AMENDMENT

ETS 300 324-1

**This amendment A1 modifies
the European Telecommunication Standard ETS 300 324-1 (1994)**

**Signalling Protocols and Switching (SPS);
V interfaces at the digital Local Exchange (LE);
V5.1 interface for the support of Access Network (AN);
Part 1: V5.1 interface specification**

Page 260, figure L.33.2

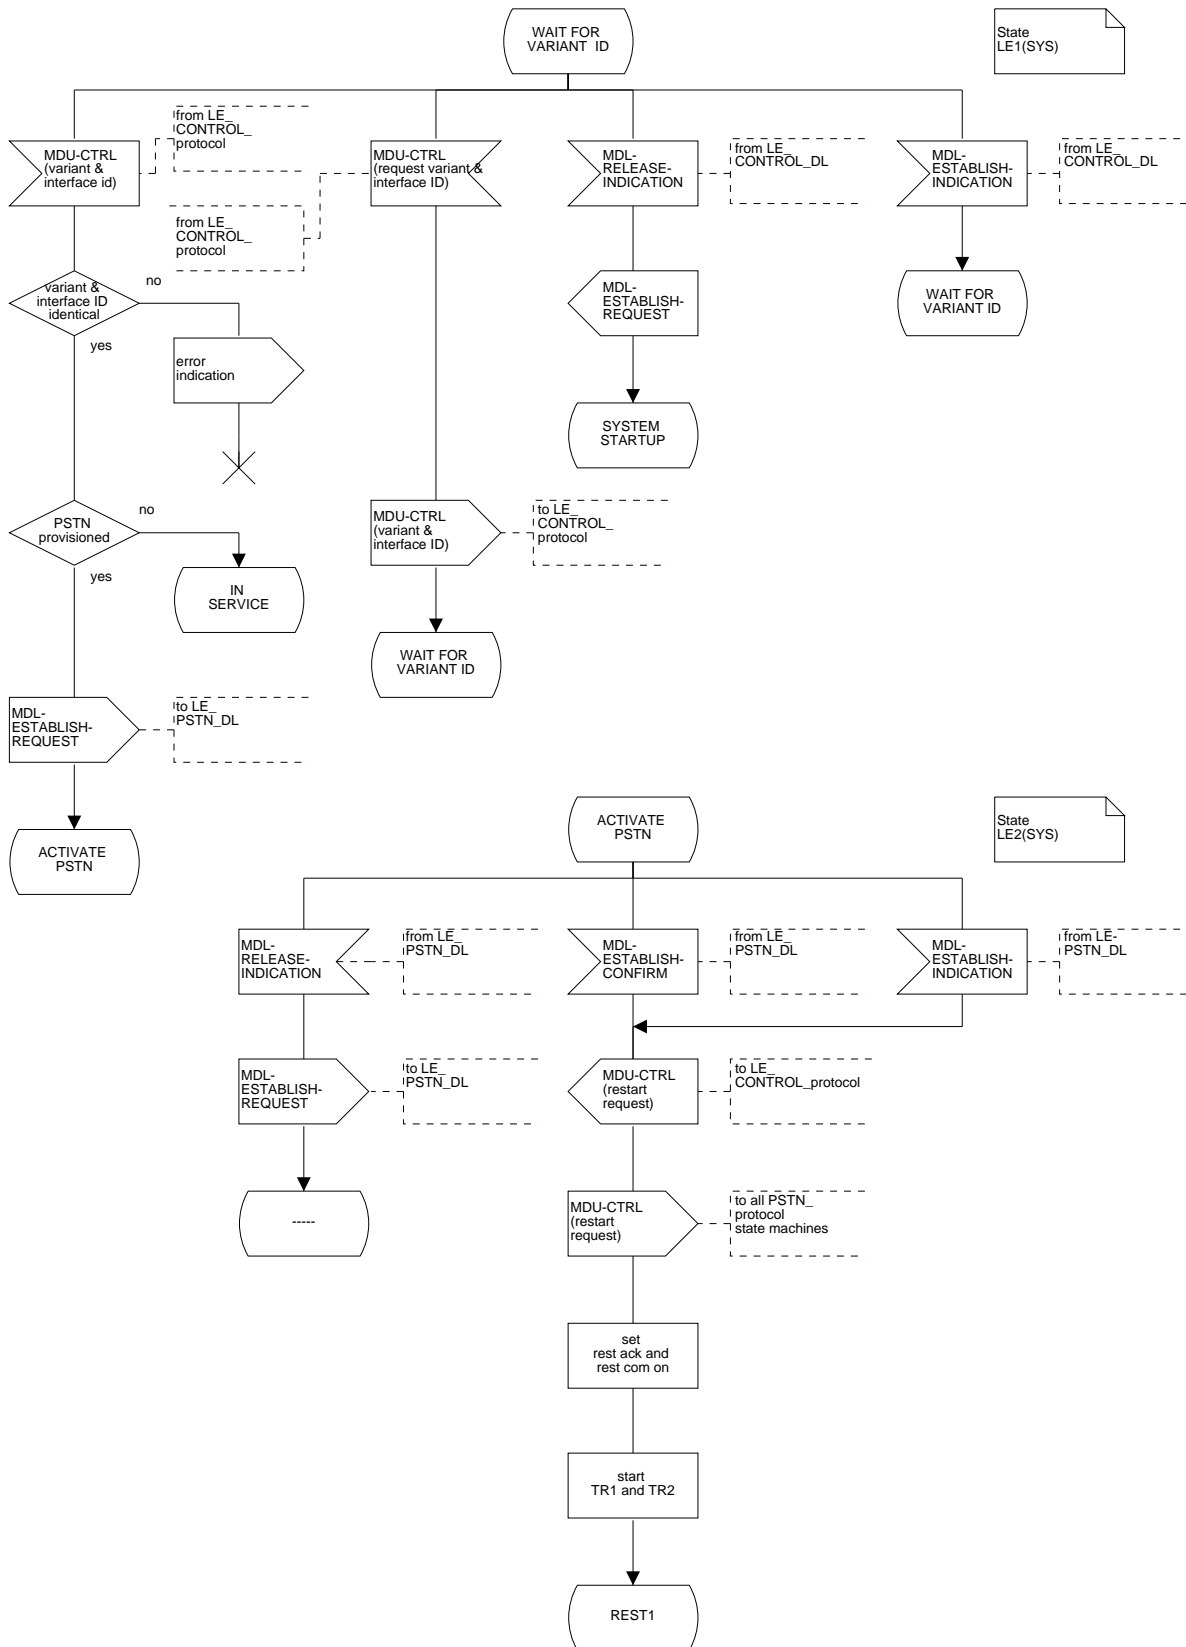
State "WAIT FOR VARIANT ID", branch "MDU-CTRL (variant&interface ID)":
Replace decision "ID identical" by "variant&interface ID identical".

State "WAIT FOR VARIANT ID":
Add a new branch "MDU-CTRL(request variant&interface ID)" as shown below.

State "ACTIVATE PSTN":
Add a new branch "MDL-RELEASE-INDICATION" as shown below.

Page 262, figure L.33.4, state "IN SERVICE", branch "MDU-CTRL (restart request)"

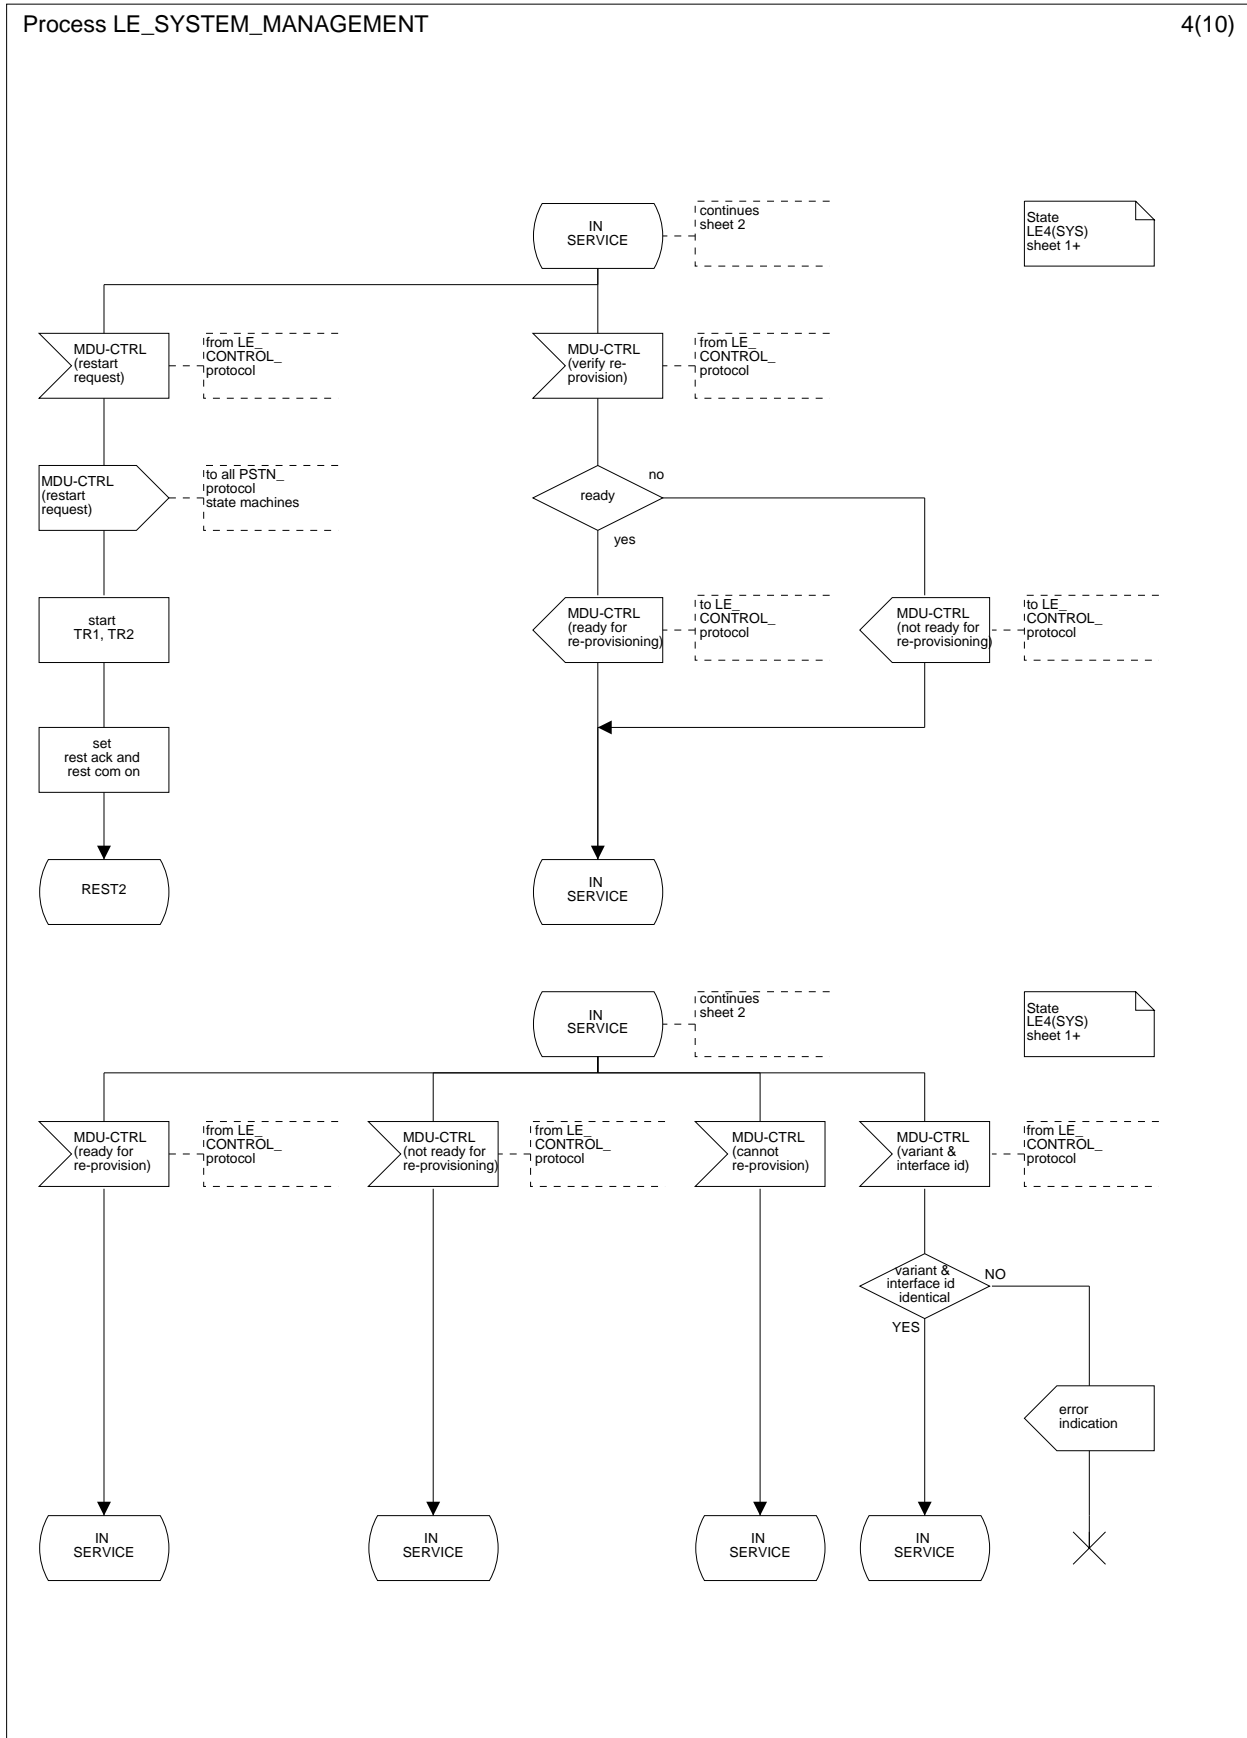
Replace task "set rest ack on" by task "set rest ack and rest com on". Replace task "start TR1" by task "start TR1, TR2".

Page 263, figure L.33.5, state "IN SERVICE", branch "MDU-CTRL (switch-over to new variant)"

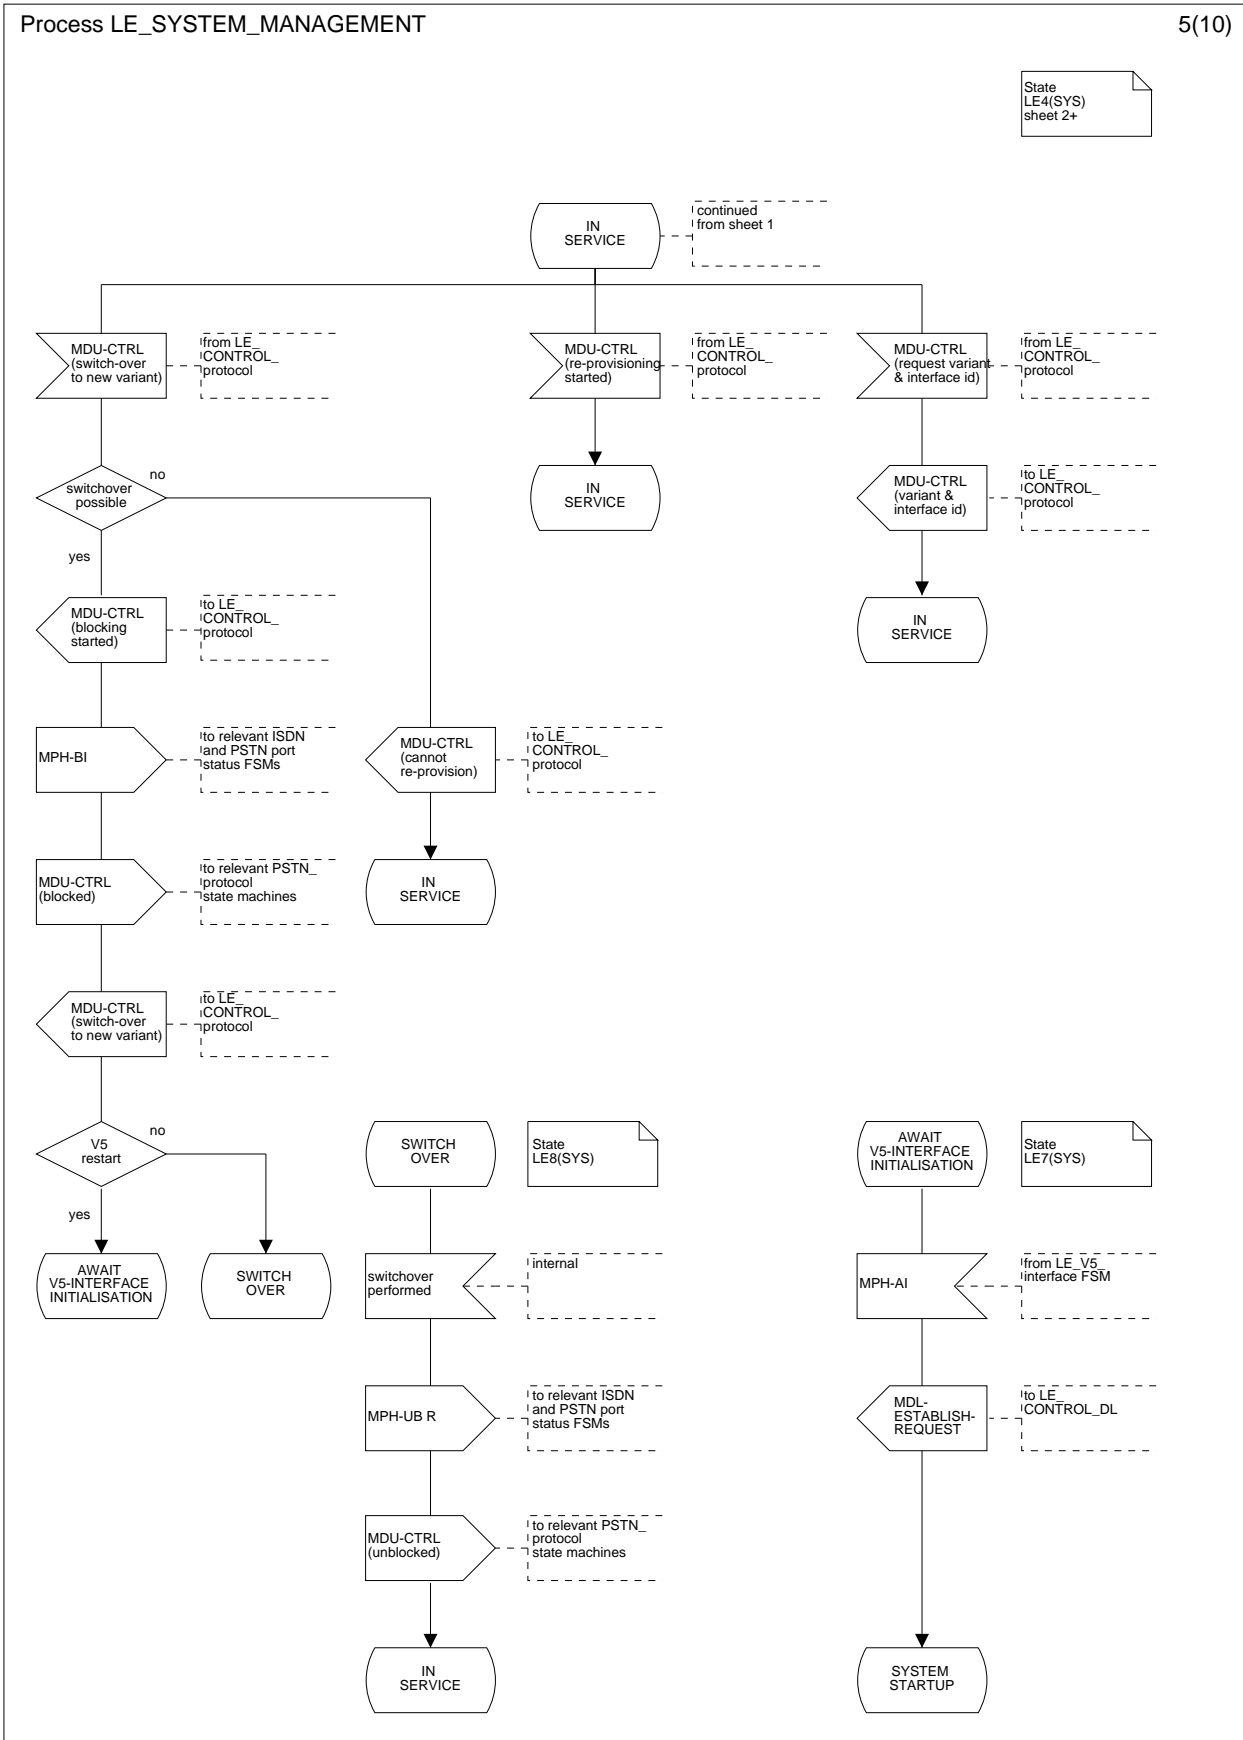
Insert sending of MDU-CTRL (blocking started) [to LE_CONTROL_protocol] after decision "switchover possible".

Page 266, figure L.33.8, state "REST2"

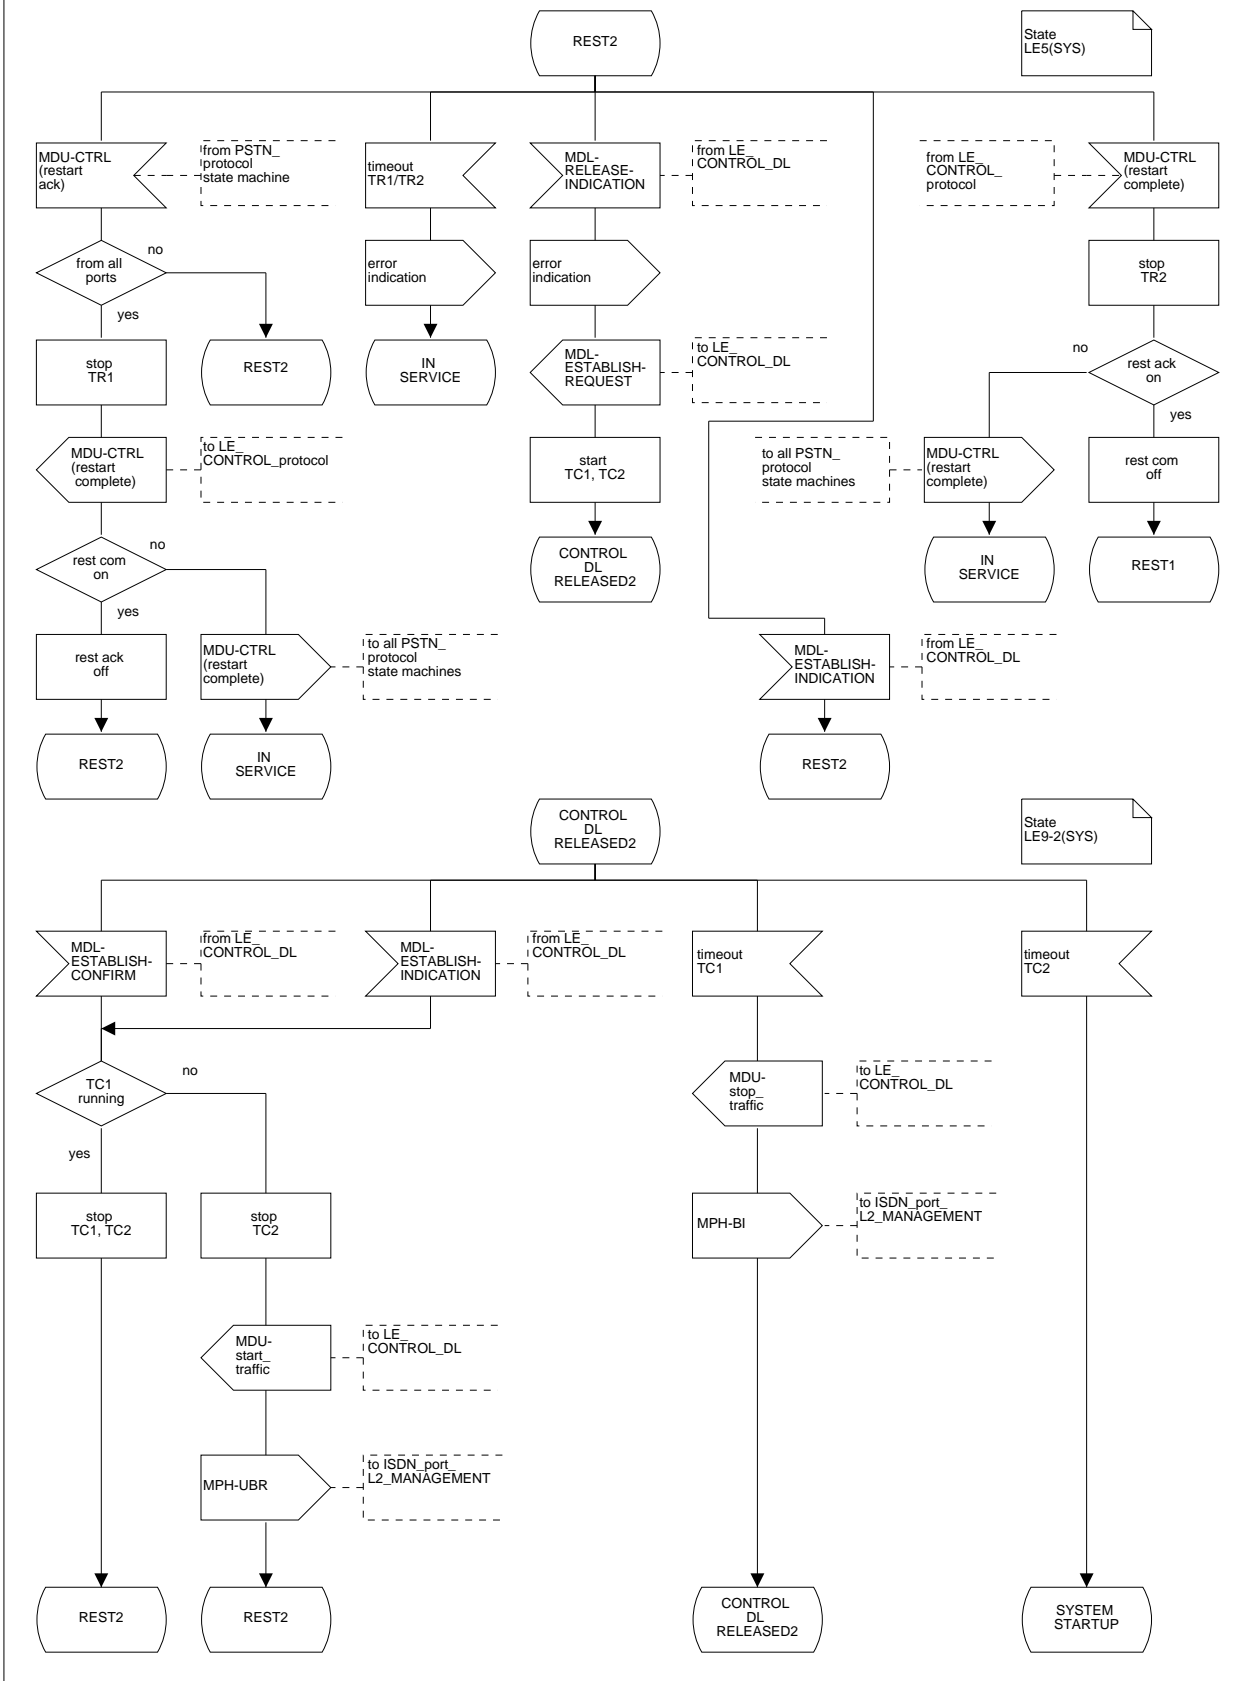
Use the same tasks as in state "REST1", branch "MDU-CTRL (restart ack)" of figure L.33.3.

Replace event "timeout TR1" by "timeout TR1/TR2".

Use the same tasks as in state "REST1", branch "MDU-CTRL (restart complete)" of figure L.33.3.
